SERVICE INFORMATION LETTER

SERVICE INFORMATION LETTER INDEX

FIGURE 1

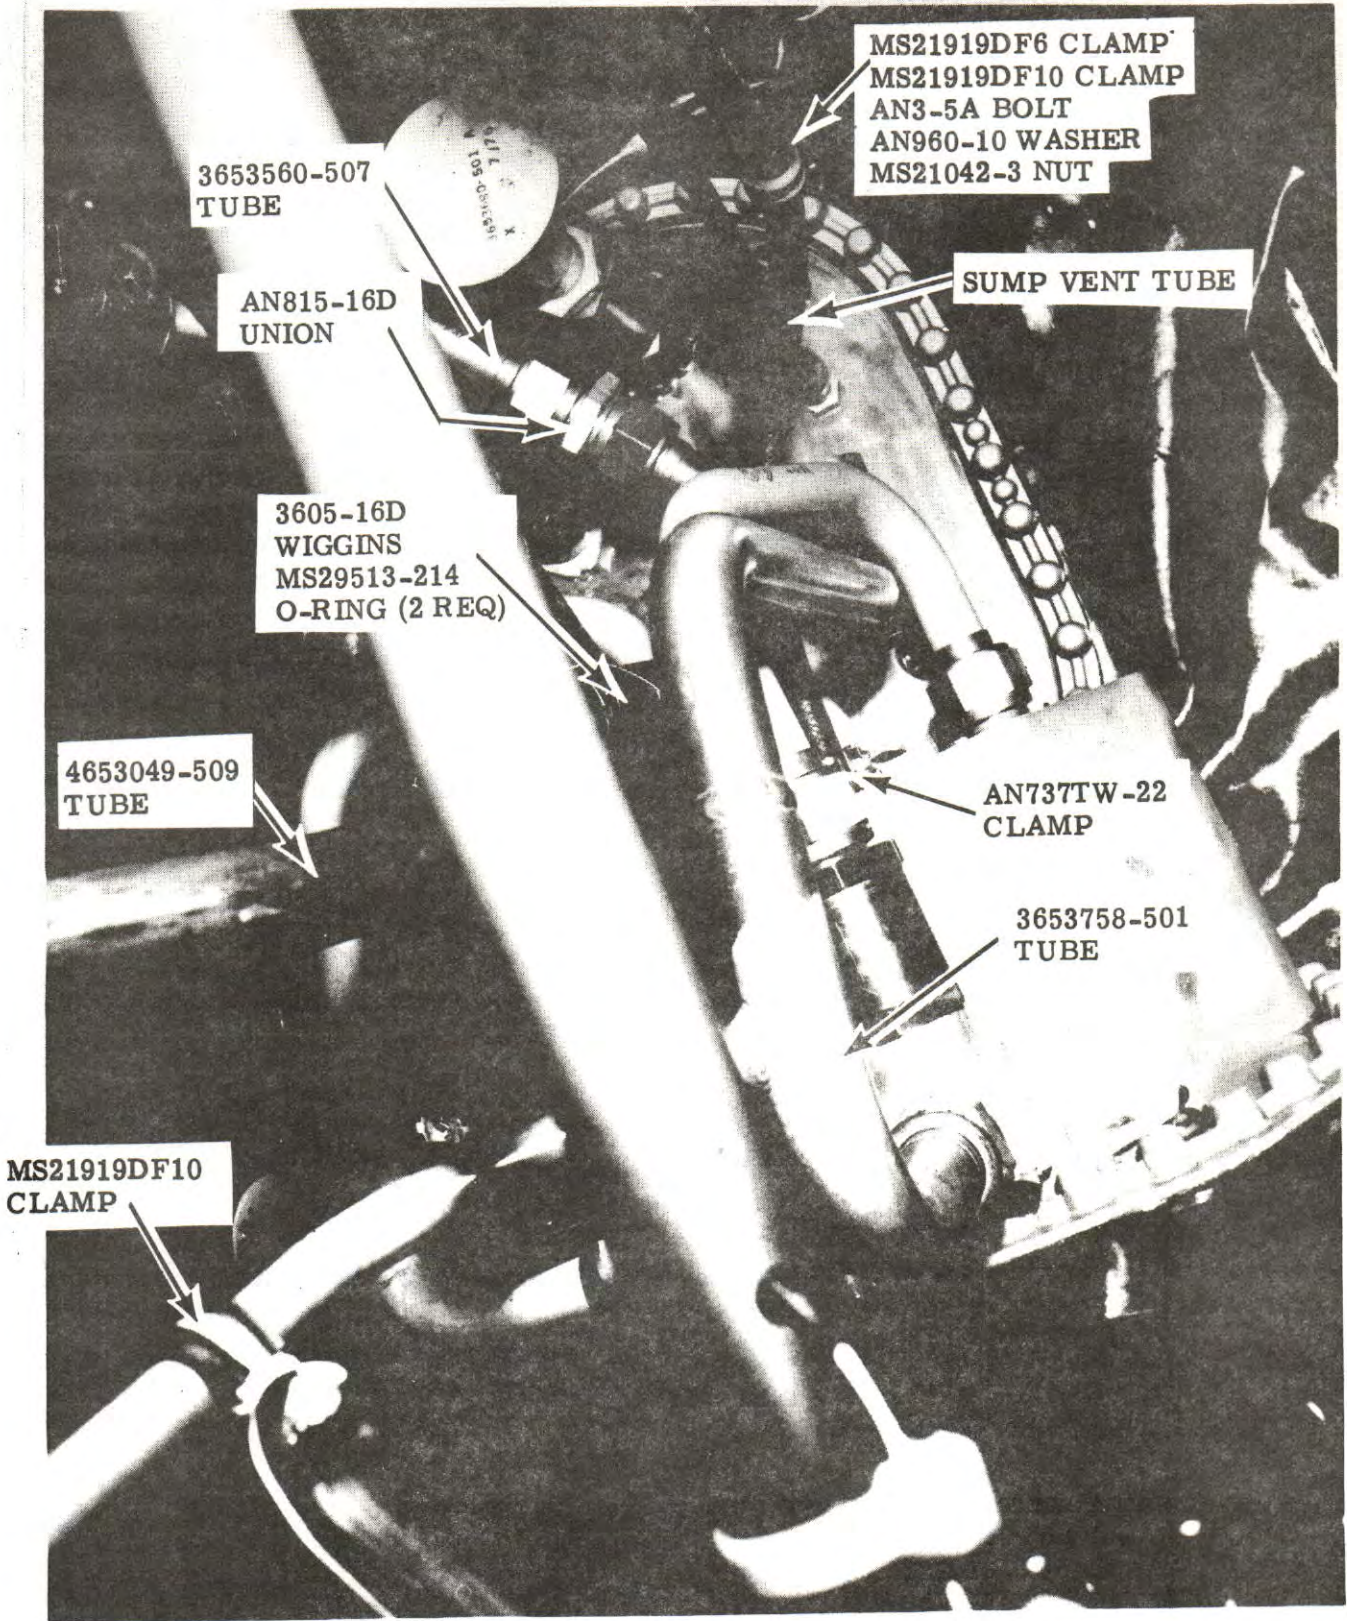
2. Assemble and install the fuel sumps as follows: (Refer to Figure 1).
- A. Install a 3653741-1 tube in each lower sump casing P/N 5653722-1-51 and 5653722-2-51 using a 4653743-505 gasket between tube flange and sump casing.

- F. Install sump to aircraft structure support bolts P/N AN4-5A and secure using AN960-416 washers and MS21042-4 nuts, (4 places on each sump).
3. Assemble and install sump check valves and tubing. (Refer to Figure 1, 1A and 1B).

6. Refer to Figure 1 and install the boost pumps as follows:

LH FUEL SUMP
FIGURE 1A

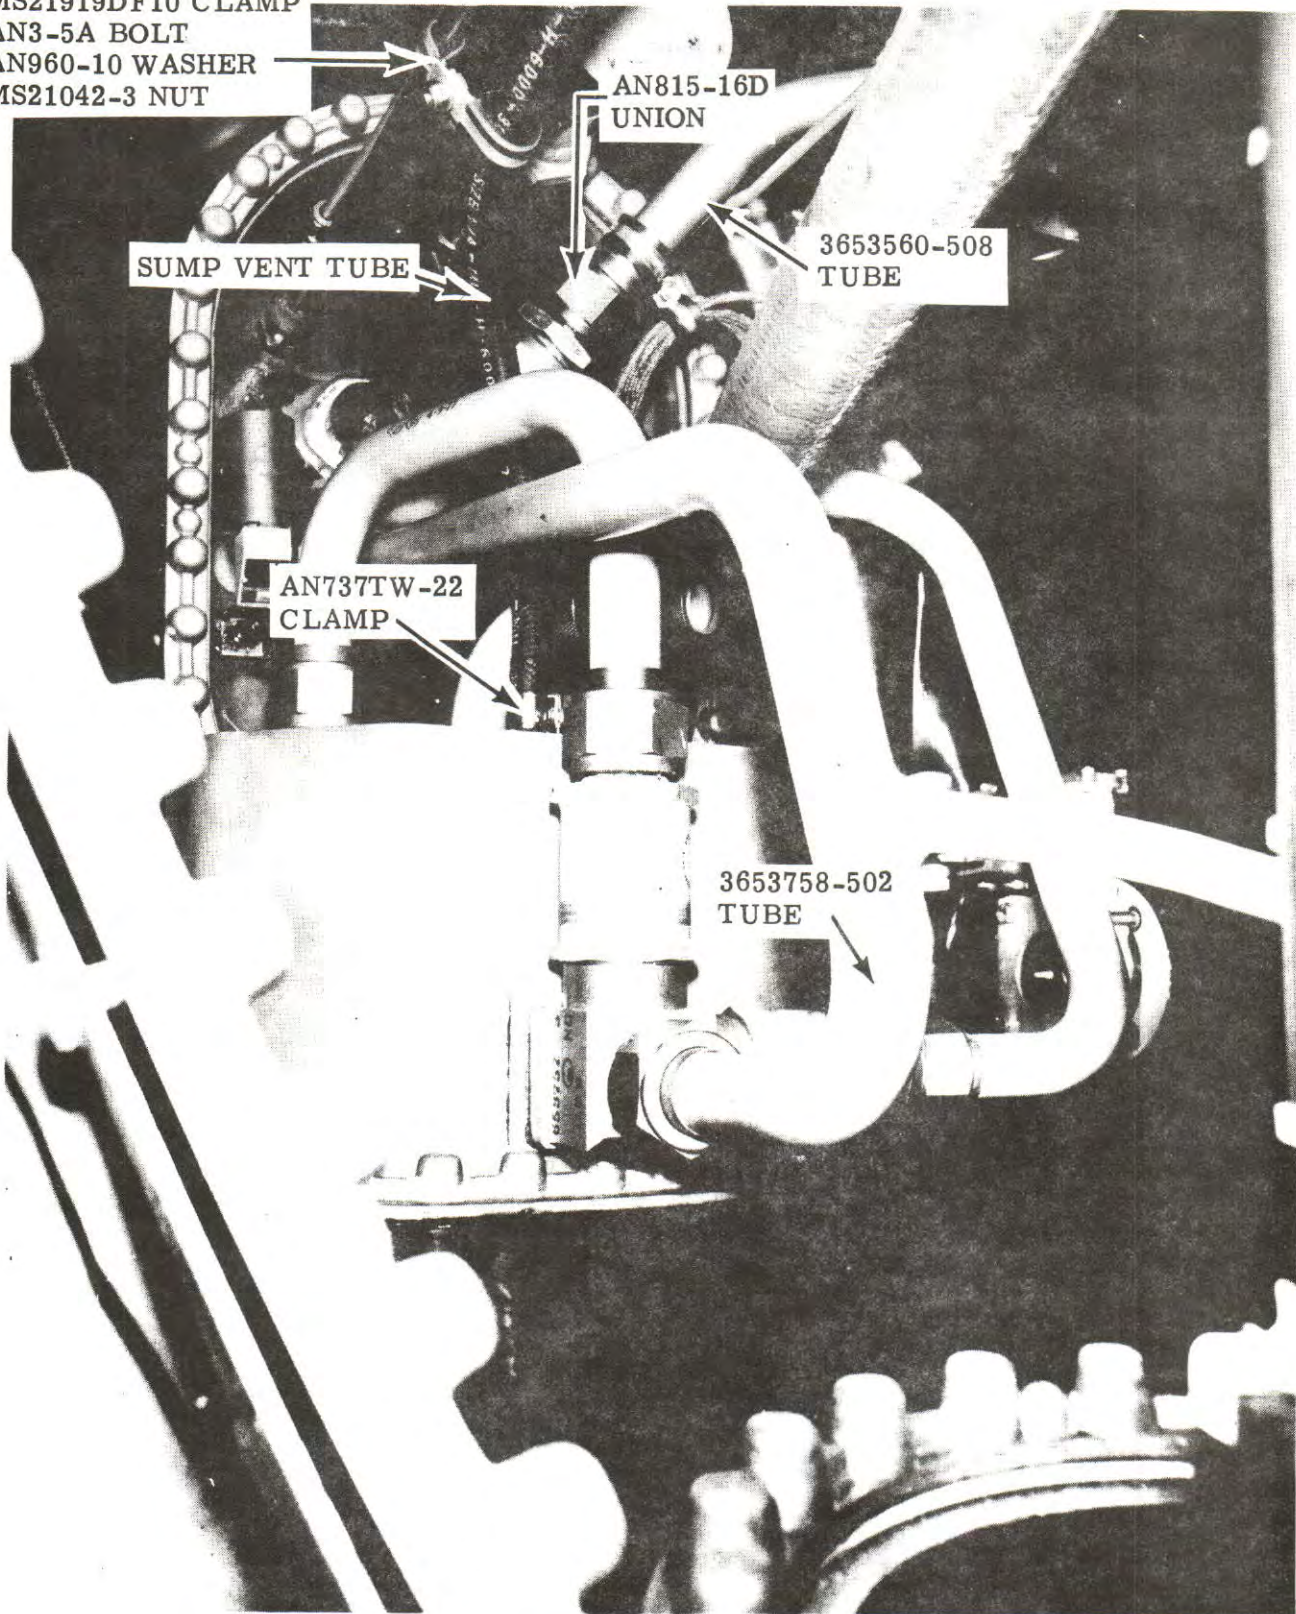
4. Refer to Figure 1A and install tubing as follows:
- A. Install LH transfer valve motive flow tubes P/N's 3653758-501 and 3653560-507 between sump cross fitting and transfer valve, interconnect tubes with an AN815-16D union. Mark flange of 3653560-507 motive flow tube to match holes in transfer valve mount bracket. Remove tube and drill mounting holes, using a No. 10 drill. Reinstall transfer valve (previously removed in Part A, Step 8D) and motive flow tube, using 2 each new gaskets P/N 5653054-531 and attaching hardware. Safety wire attaching bolts.
